UNITED STATES OF AMERICA
FEDERAL ENERGY REGULATORY COMMISSION

Utah Board of Water Resources,)
Lake Powell Pipeline Project) P-12966-001
_____)

**LAKE POWELL PIPELINE COALITION’S COMMENTS ON THE
PRELIMINARY LICENSING PROPOSAL AND DRAFT STUDY REPORTS**

Figure 3. Historical and Projected Supply, Use, and Demand

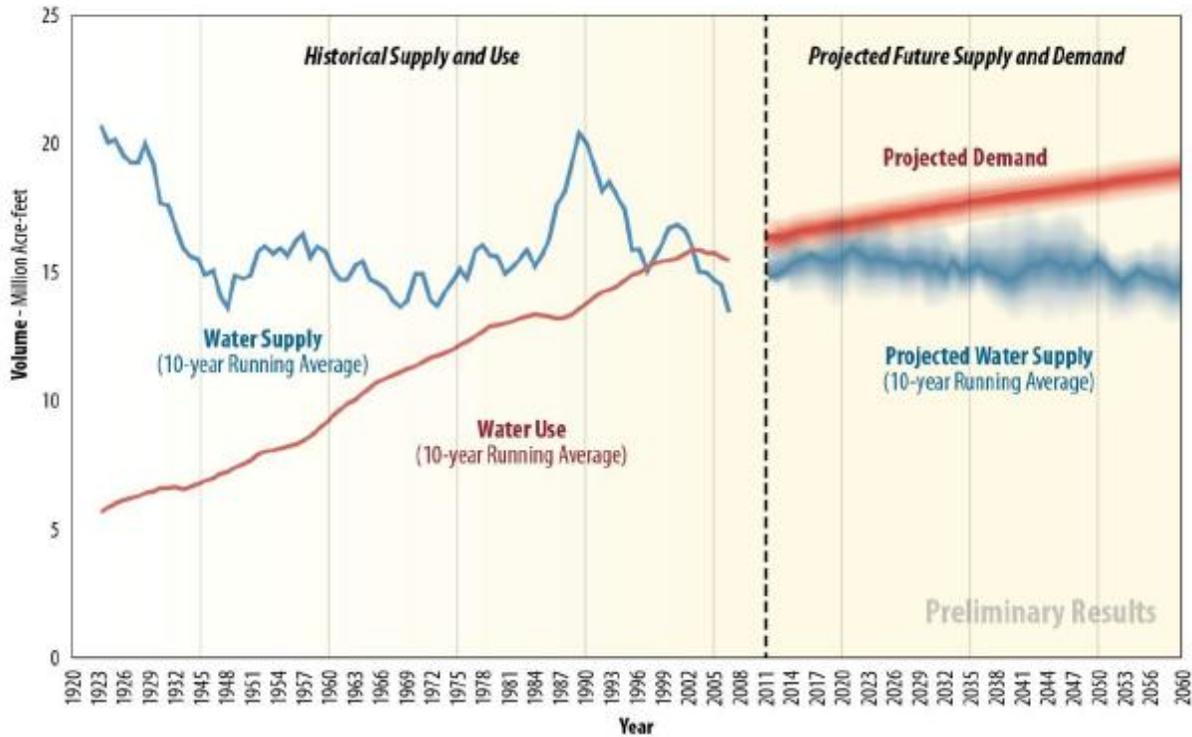
In Figure 3, the Bureau of Reclamation, depicts 10-year average supply and demand totals for the Colorado River basin, and illustrates that since 2002 demands have exceeded supply. This is nowhere more evident than in the declining volume of water in storage throughout the basin. The Project proponents must acknowledge that while new demands for Colorado River water may be supplied out of storage in the short term, the inevitable, long-term result is that a new demand in a system already fully used will either itself be shorted, or will result in a shortage to another water use somewhere else in the system.⁶⁰

The red line represents the water supply and the blue line represents water demand. Figure 3 illustrates clearly that a supply and demand imbalance currently exists in the Basin. This imbalance will grow in the future if major changes are not made in how we use water.

Figure 4. Lake Powell Projected Elevations

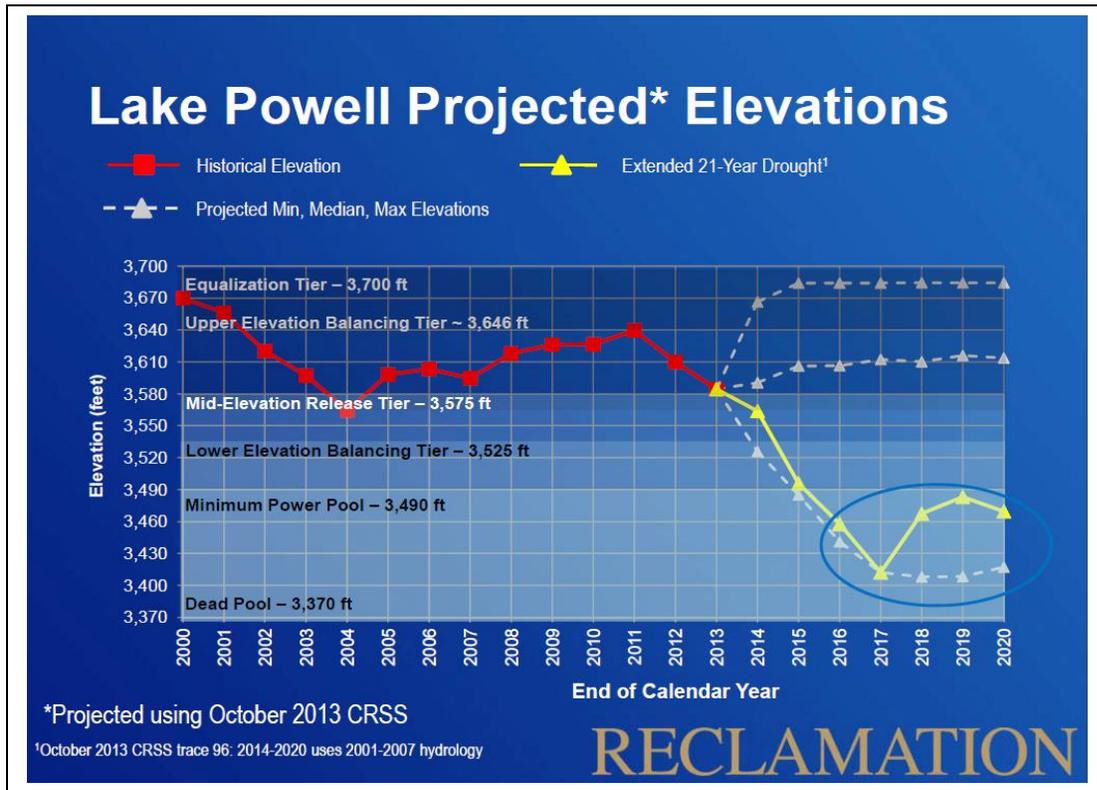
On the contrary, a Bureau of Reclamation chart, Figure 4, shows that if the drought continues from a fifteen year to a twenty-one year drought, the elevation of Lake Powell could fall below the minimum power pool level.

Figure 5. Glen Canyon Dam Penstocks at 42% Capacity⁶³

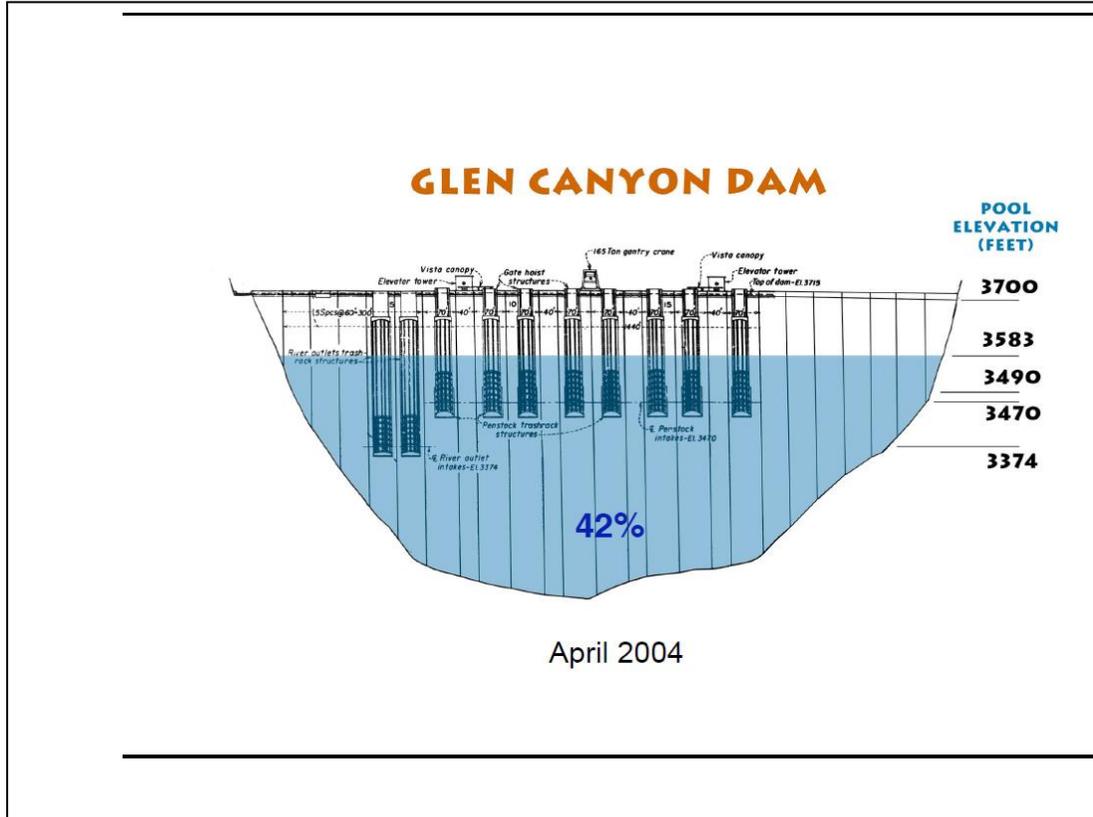
The level of the Lake Powell has an impact on the amount of power that will be generated, as water levels in the lake decrease less power will be being produced. Therefore the issue is not only if the reservoir level goes below the minimum power pool elevation, but what impact the Project will have on reduction of kilowatts produced at the lower proposed intake levels.

Figure 5. illustrates the Project’s first intake at 3574 msl. When Lake Powell is at 42% capacity the water covers half of penstocks.

Figure 6. Glen Canyon Dam Penstocks at Minimum Power Pool 3490 msl

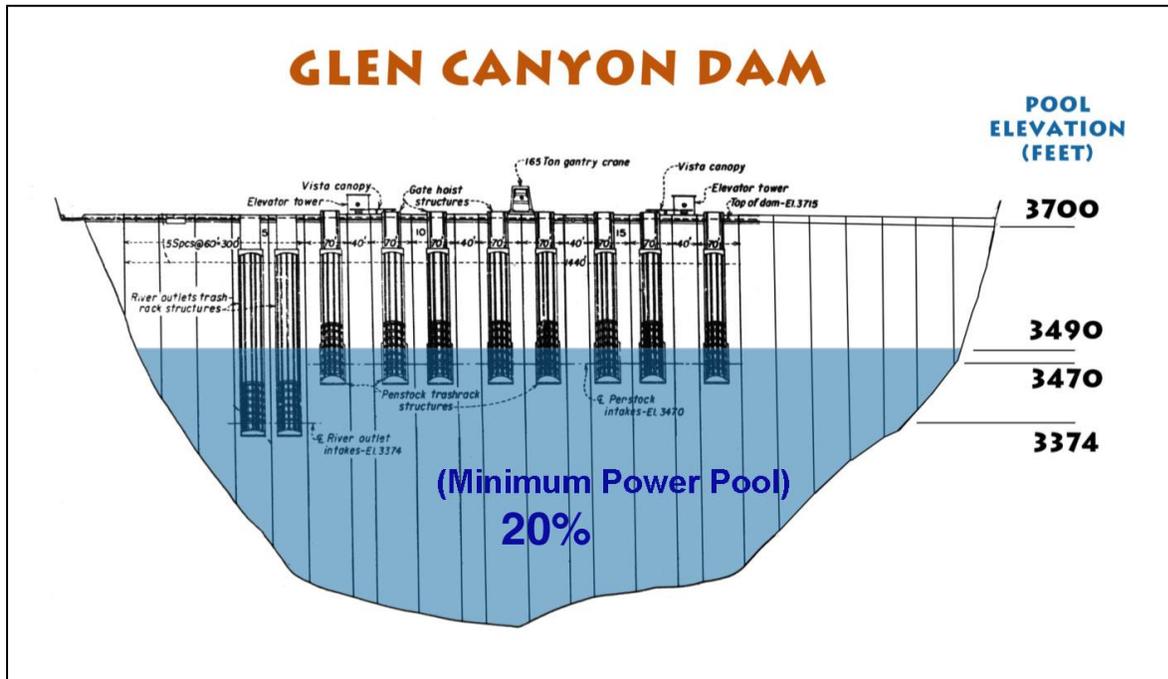
Figure 6. Illustrates the minimum power pool elevation in Lake Powell at 3490 feet msl. The Project’s second intake is at 3474 msl in Lake Powell, which is 16 ft. below minimum power pool elevation in Lake Powell

Figure 7. Glen Canyon Dam Penstocks at Dead Pool

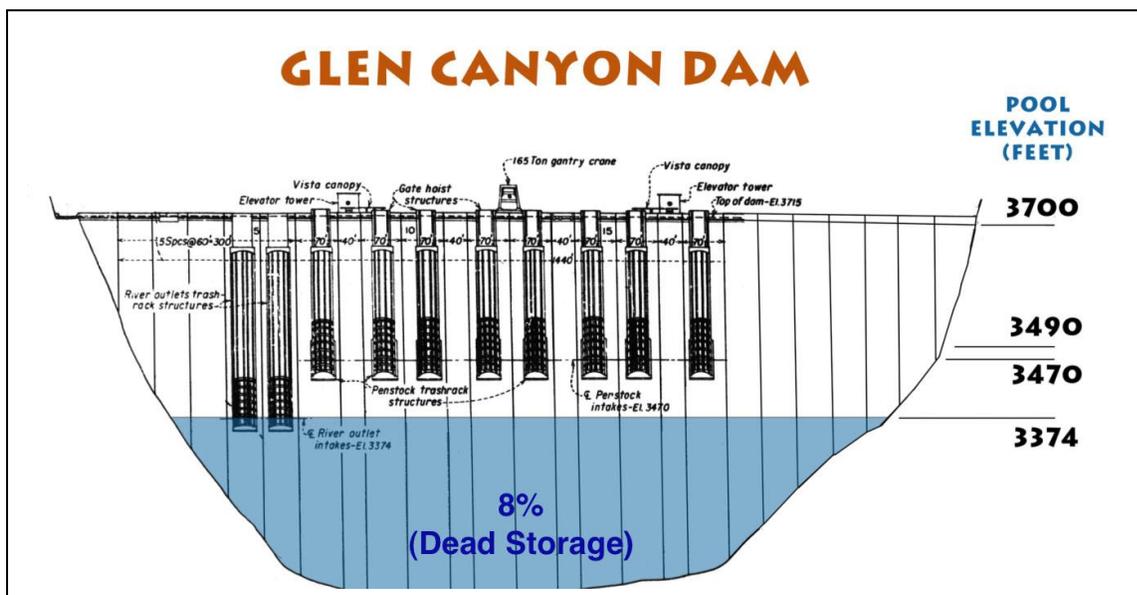
The third intake is at 3375 msl, which is 5 feet above dead pool in Lake Powell.

Figure 8. Per Capita Use Washington County

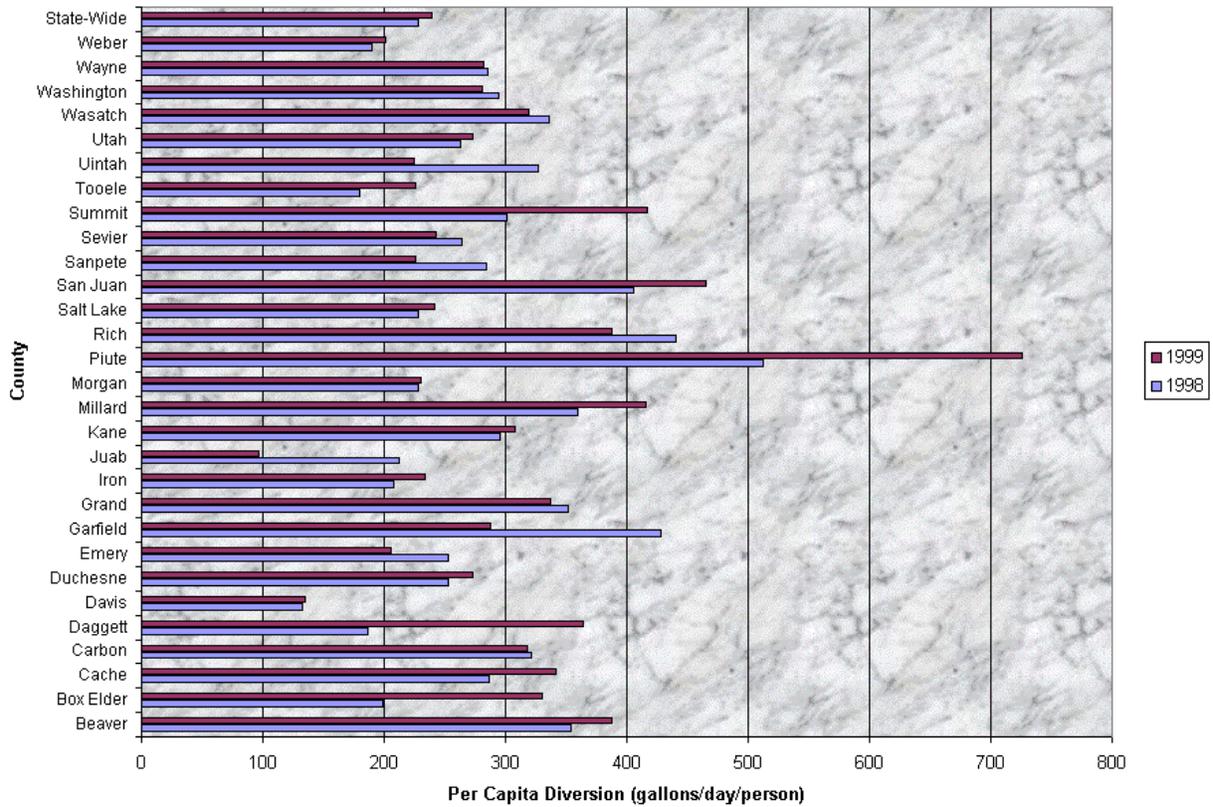
Additionally the Division of Water Rights in its 2000 water report indicates the gpcd was less than 300 gpcd. See Figure 8 below.⁷⁴

Figure 13. Utah's Water Use Since 1990¹⁰¹

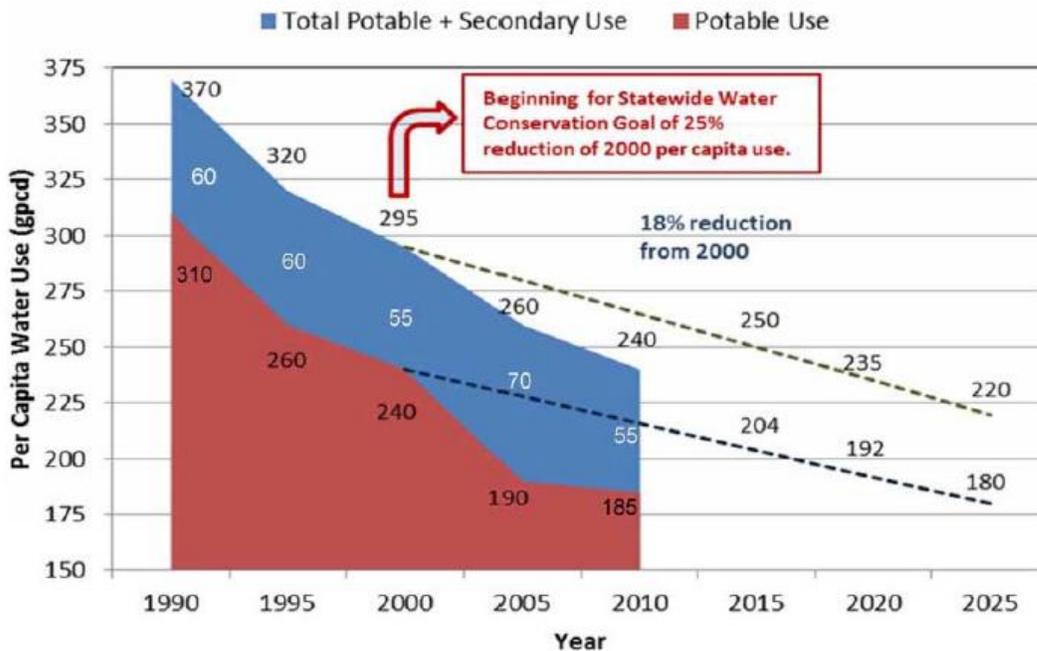
The Auditor’s report explained its concerns with the accuracy of accounting for secondary water statewide by referring to this chart below (Figure 13).

The Auditors report also shows the problem with UBWR adding on 55 gpcd as a standard for secondary water without justification throughout the state.¹⁰² They wrote, “volatility in the reported secondary water use raises doubts about the comparability of past water studies. It also raises questions about the accuracy of the report that water use has declined by 18 percent from 2000. The Division of Water Resources Figure 13 shows large fluctuations in secondary water use (shown in blue) during 2000, 2005, and 2010. It shows secondary water use in 2000 was 55 gpcd. This is the difference between year 2000’s total water use of 293 gpcd and the potable use of 240 gpcd. In 2005, that reported secondary water use rose to 70 gpcd. Then it declined to 55

Figure 14. WCWCD 2010 Per Capita Water Use¹⁰⁵

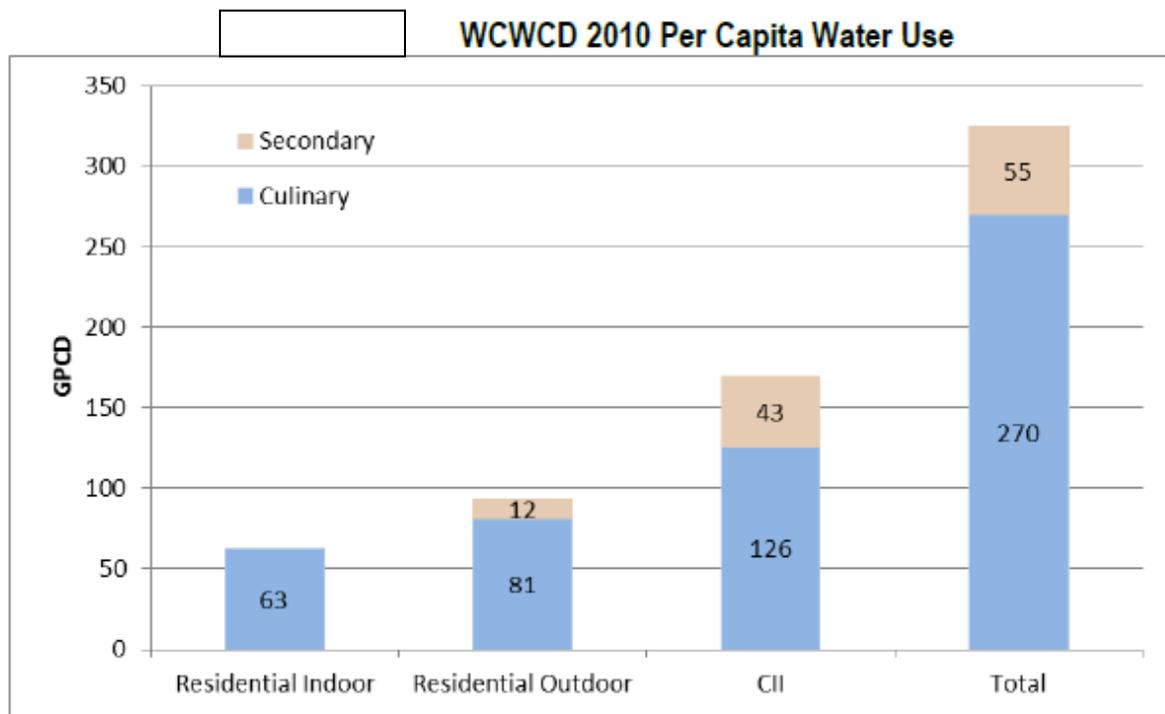
¹⁰⁵ This chart above, Figure 14, Page 3-2 WNA, shows how the extra 55 gpcd is added to per capita use in Washington County that overstates water demand. The per capita use is explained by UBWR below

Figure 16. Comparison of City Water Rate Structures¹²⁰

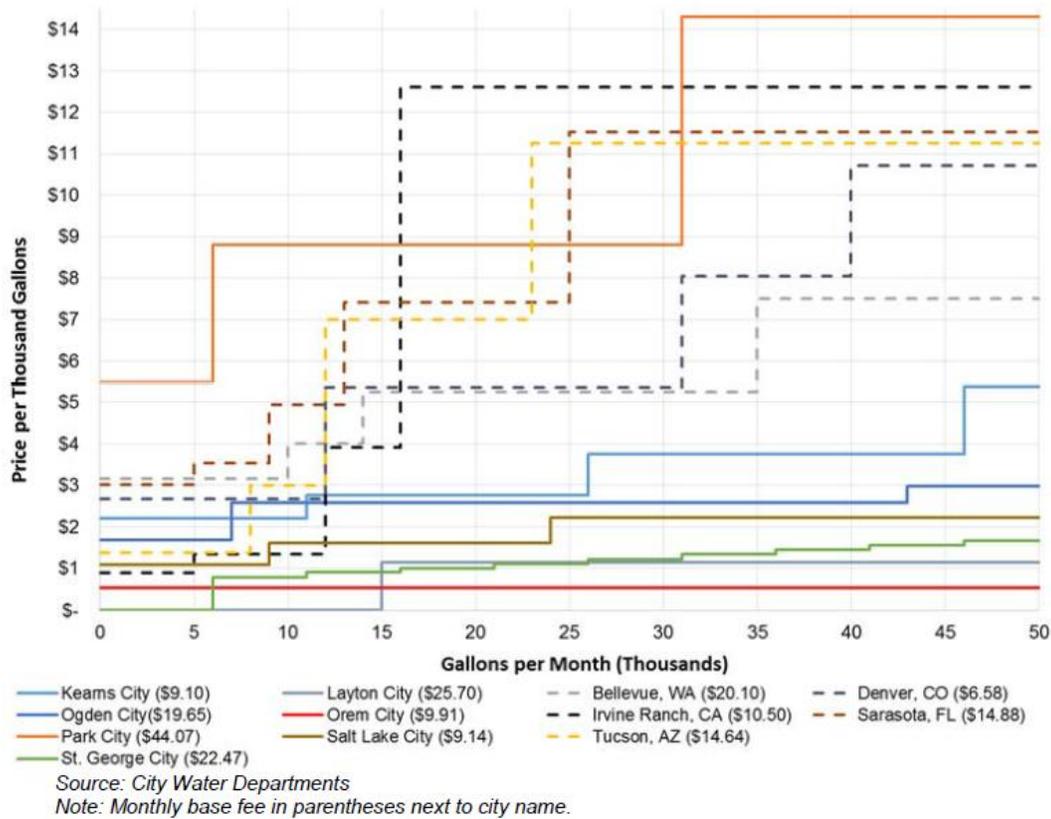
However, the cities do have block step pricing, but they do not have steps that signal conservation and are relatively flat. This is noted on chart from the audit below Figure 16.
